DEVELOPMENT REVIEW COMMITTEE (DRC) COMMENT SHEET
CITY OF ROCKWALL ♦ PLANNING AND ZONING DEPARTMENT
PHONE (972) 771-7745 ♦ FAX (972)771-7748 ♦ PLANNING@ROCKWALL.COM

Project Number: SP2008-023
Project Name: Larsen Retail Development
Project Type: SITE PLAN
Project Subtype:

**LARSEN RETAIL DEVELOPMENT
3.339 AC. TRACT
LARSEN SCHOOL ADDITION
ROCKWALL, ROCKWALL COUNTY, TEXAS**

SITE PLAN DATA

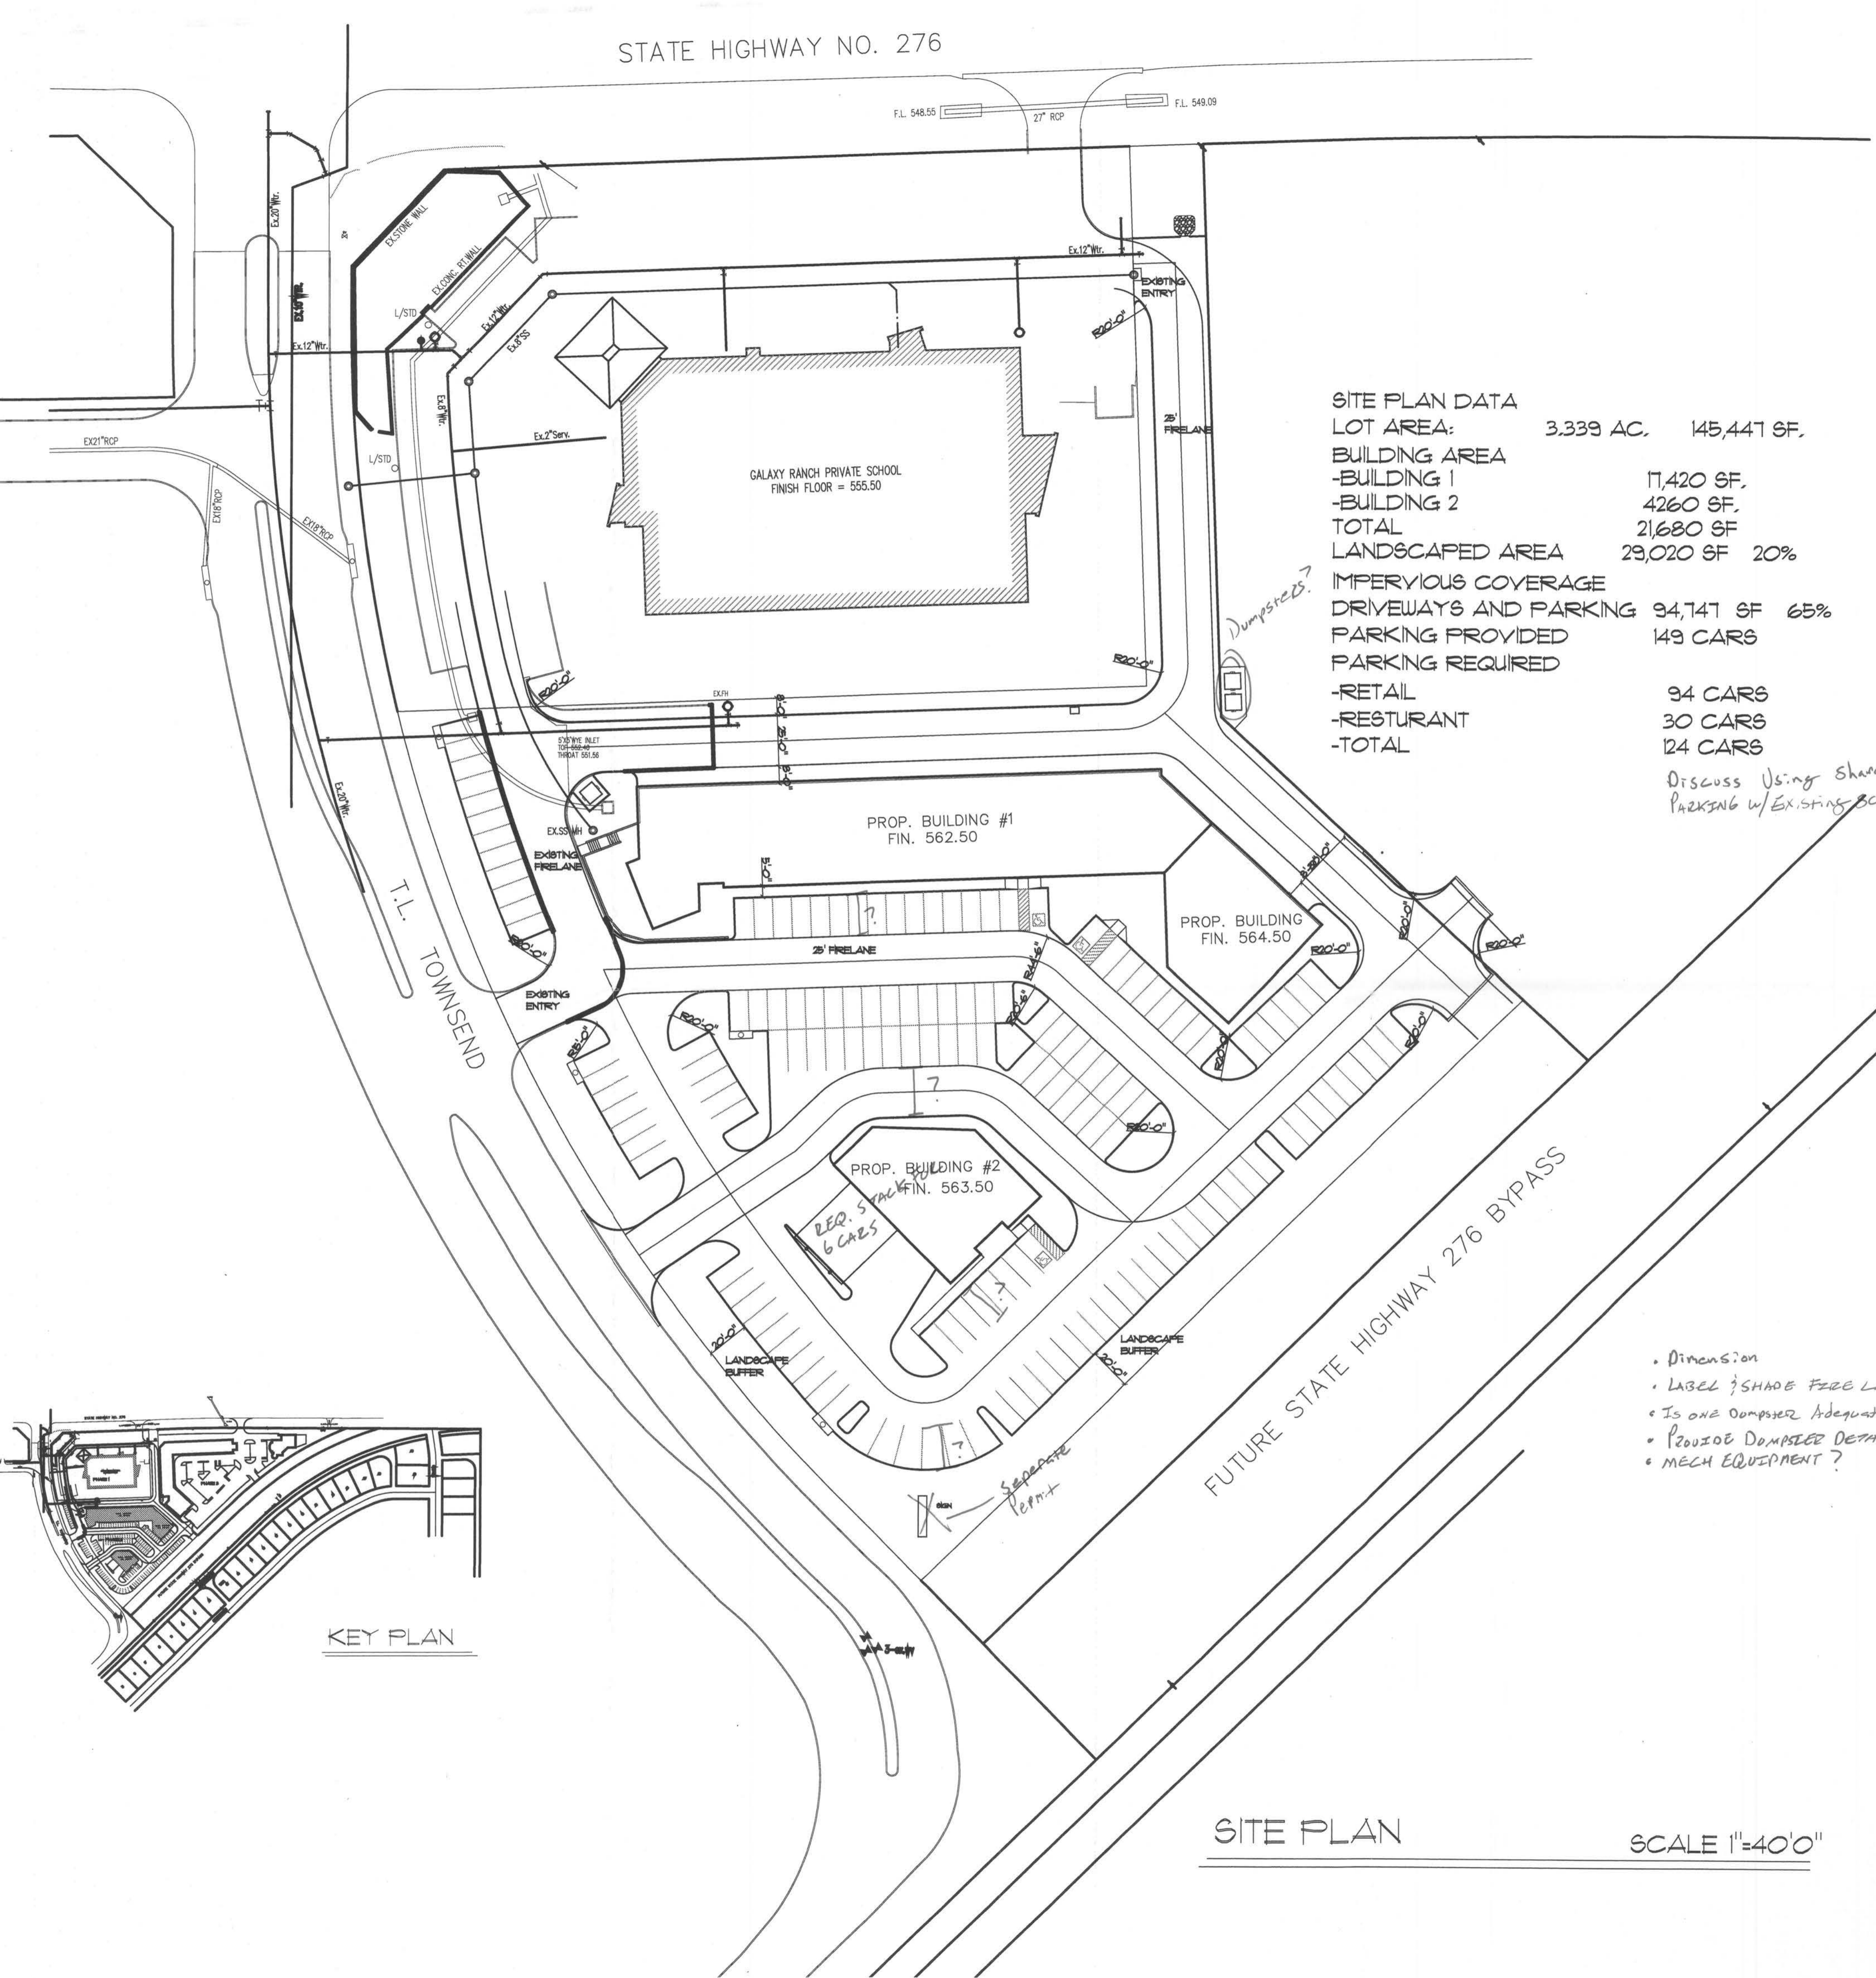
Discuss Using Shared Parking w/ Existing School

- Dimension
- LABEL ? SHADE FREE LANE
- Is ONE DUMPSTER Adequate ?
- PROVIDE DUMPSTER DETAIL.
- MECH EQUIPMENT ?

Elevations
LARSEN RETAIL DEVELOPMENT

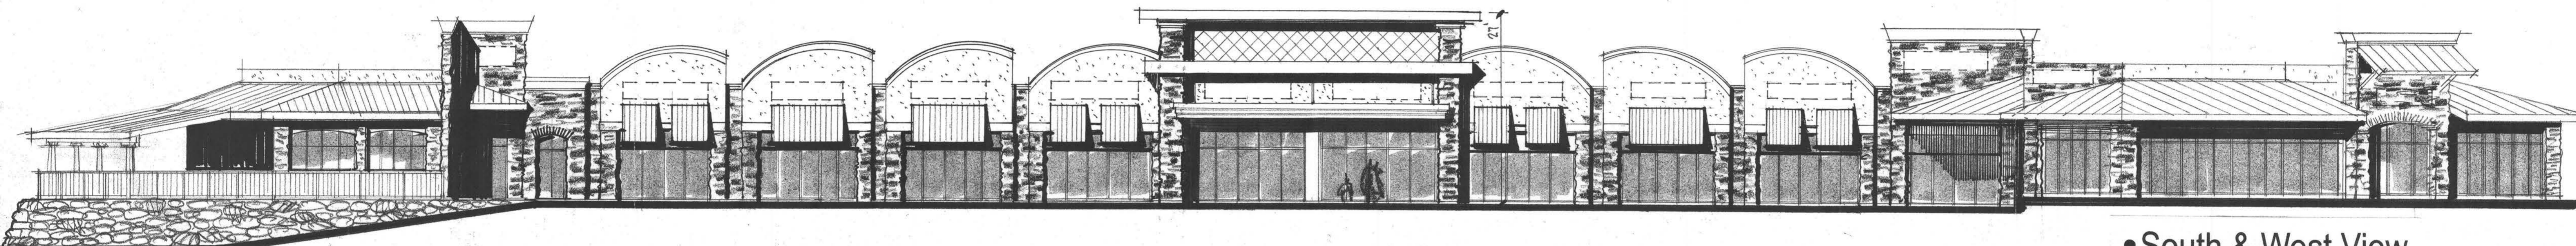
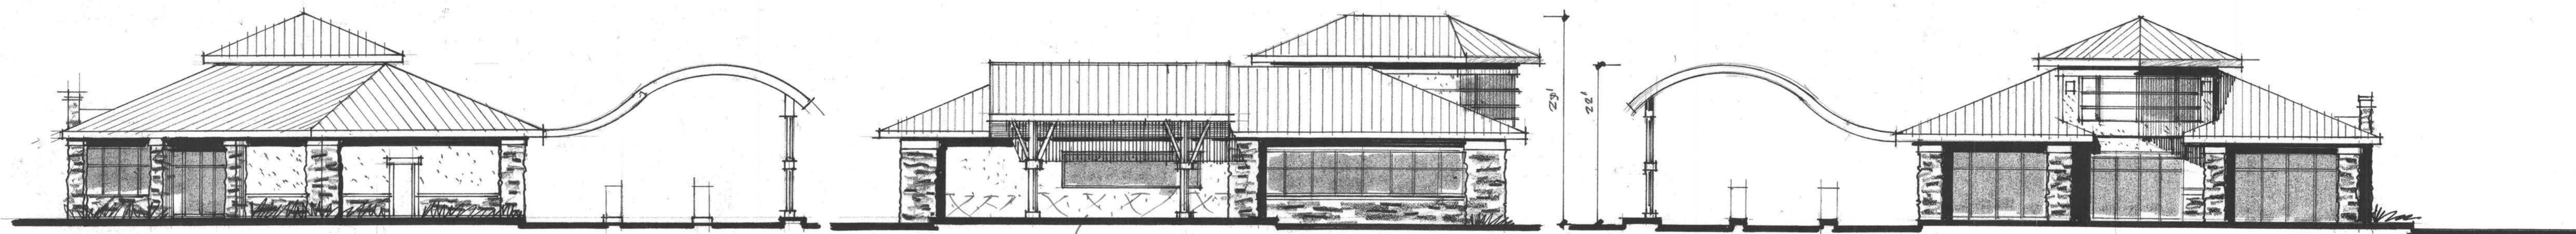
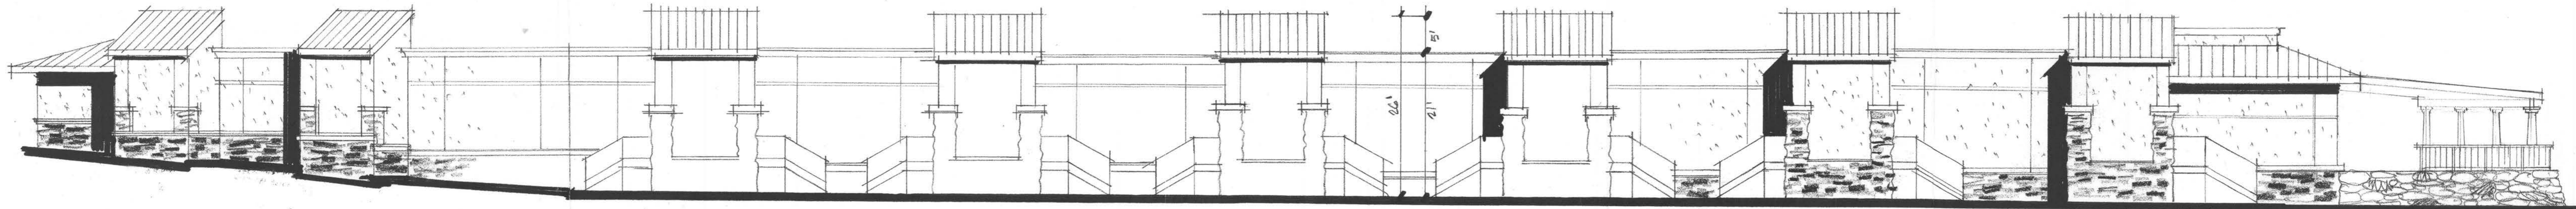
NO STUCCO IN FIRST
4'

• % OF MATERIALS FOR EACH FACADE

PHASE 2 LANDSCAPE PLAN SCALE 1"=50'

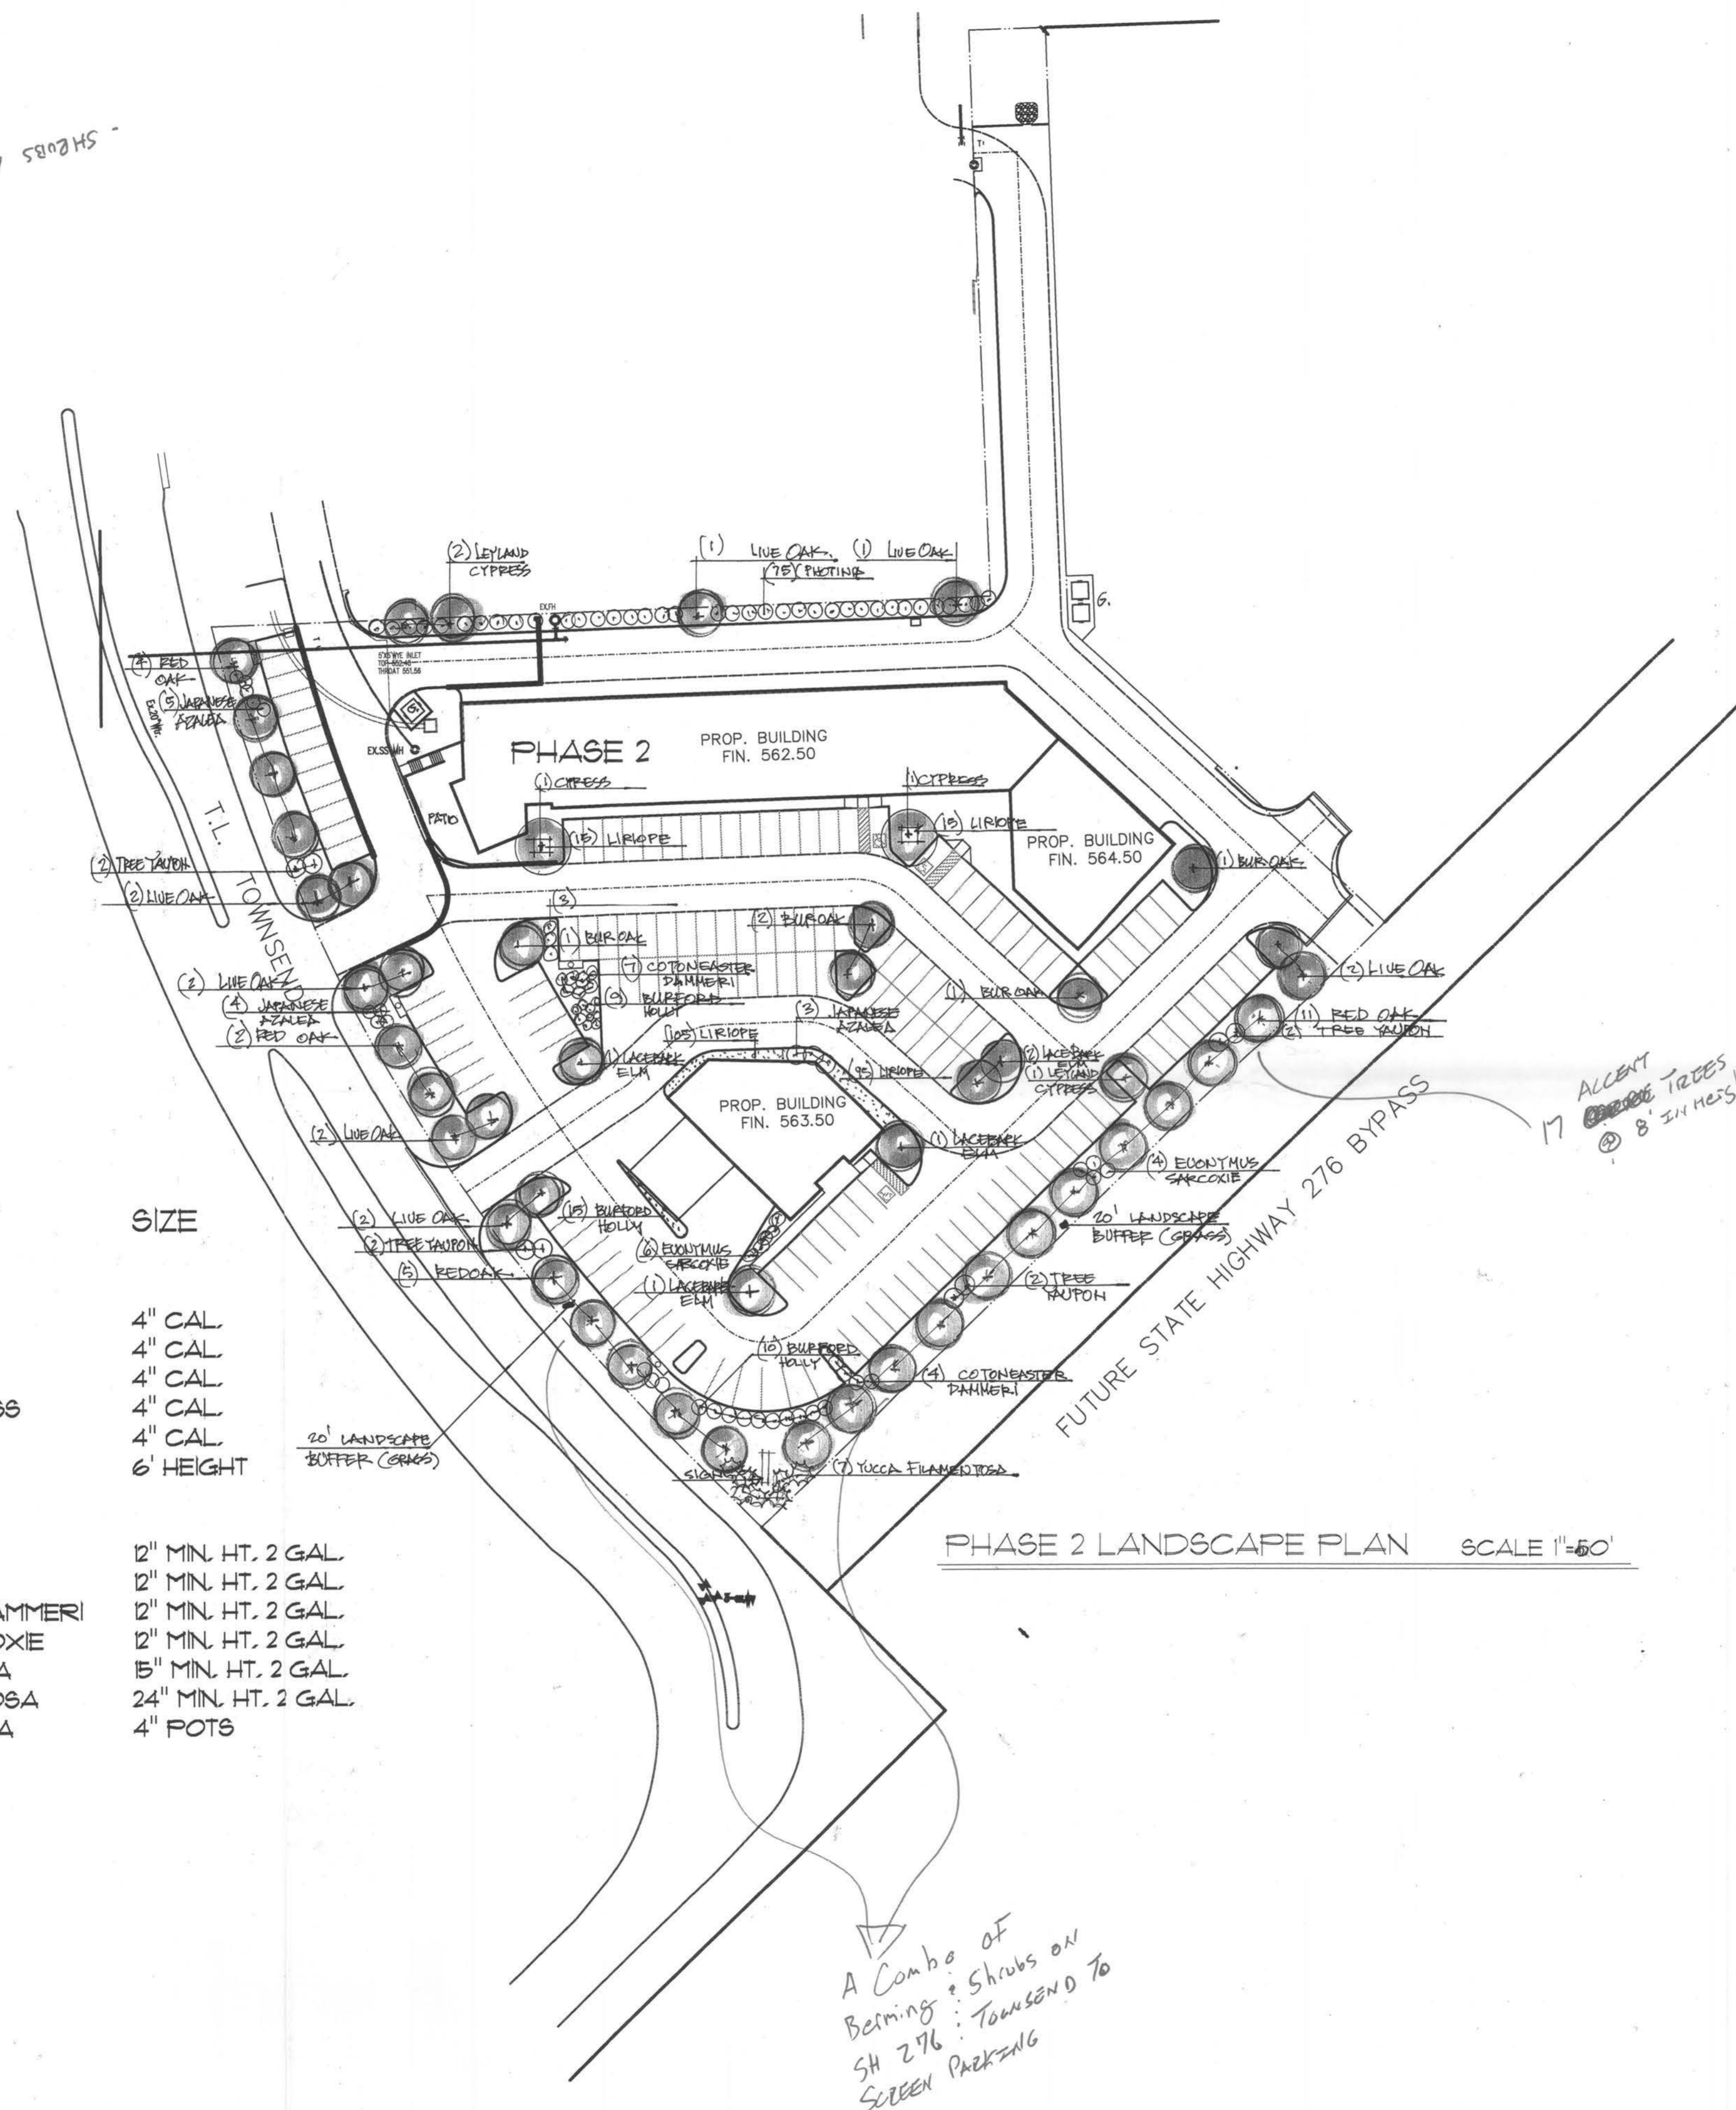
SHRUBS ALONG BOTH FRONTAGES

A Combo of
Berms + Shrubs on
SH 276: Townsend To
SCREEN PARKING

17 ACCENT TREES
8" IN HEIGHT
